NOTICE TO TENDERERS NO: 16

TENDER NUMBER: 277Q/2024/25

DESCRIPTION: Construction of a 300Ml Reservoir, Bulk Pipelines and Associated Infrastructure near Muldersvlei

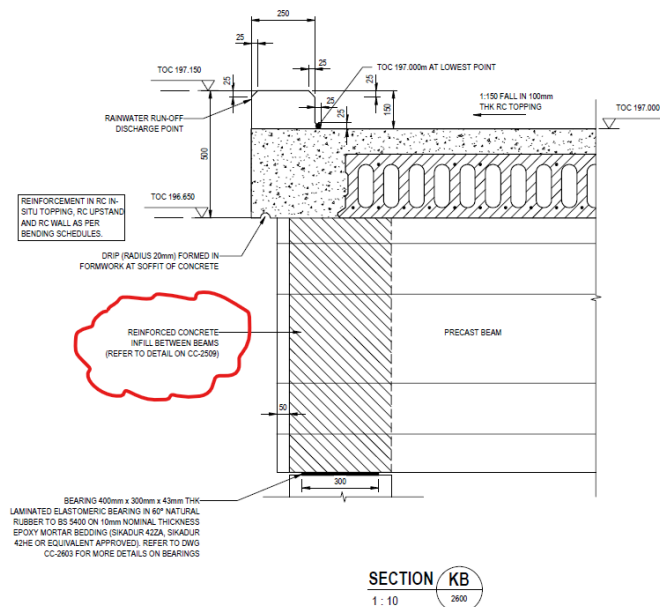
Q: The screenshot below is taken from drawing 1001757-2000-DRG-CC-2602-T0. Reference is made to "reinforced concrete infill between beams (Refer to detail on CC-2509)". Please provide us with drawing CC-2509.

A: The reference to Drawing CC-2509 is incorrect. The relevant detail is given on drawings CC-2591 (Detail 01) and on drawing CC-2602 (Run-off discharge Detail).
